An Bord Pleanála Ref: PA 0034

Proposed Alexandra Basin Redevelopment

Reply to Request for Further Information

Fig. 2.1

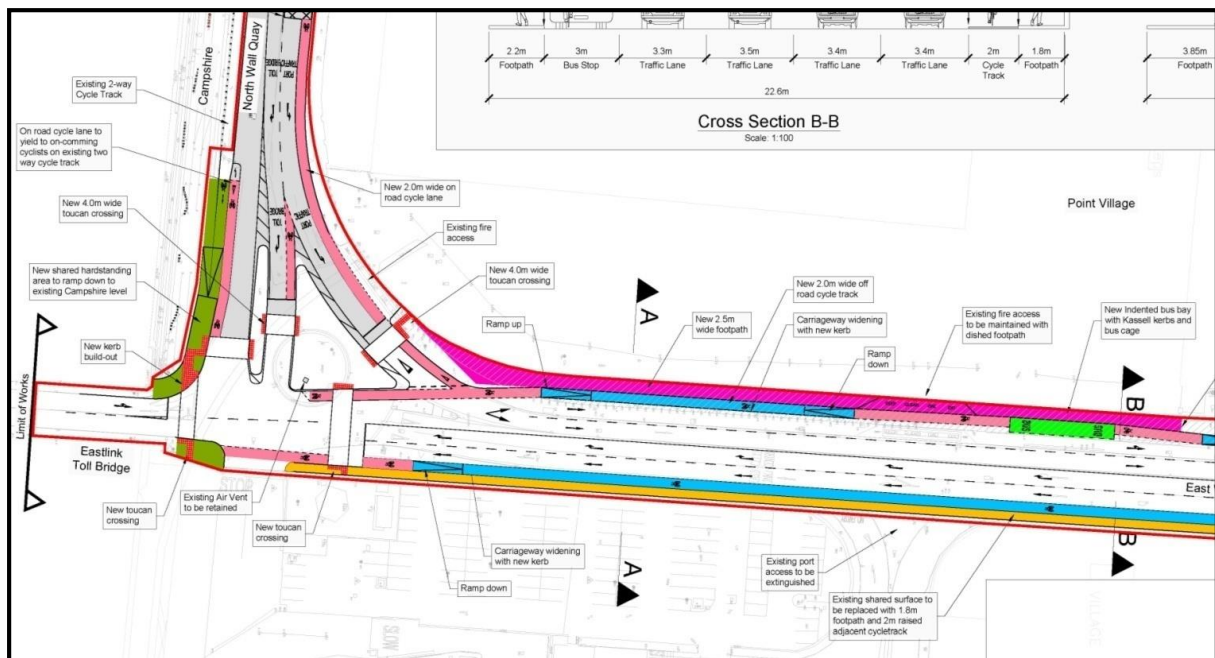
The Board is not satisfied that the quality of linkage between the proposed development and the City has been adequately demonstrated. The applicant is requested to submit details supported by appropriate drawings, clearly illustrating how it is proposed to improve integration between the proposed development and the City. These details should address in particular the following:

- *Pedestrian connectivity between the Campshire/Quay and Cruise area/ Interpretative zone;*
- *Connectivity between the cruise area and Luas/North Docklands; and*
- *Connectivity for bus traffic to the amenities of the City, which might consider more direct alternatives to the proposed Promenade Road Route.*

Fig.2.1 below is an extract from the DCC/Arup drawing (Drg. Ref. No.TO100-01) relating to the pertinent section of the improvement scheme at the current Point/3Arena roundabout showing the planned pedestrian crossings.

The plan shows a signalised junction in place of the existing roundabout incorporating signalised pedestrian and cycle crossings at the northern side of the East Link Toll Bridge thus creating a direct and safe pedestrian link between the Campshires and the Cruise/Interpretive area.
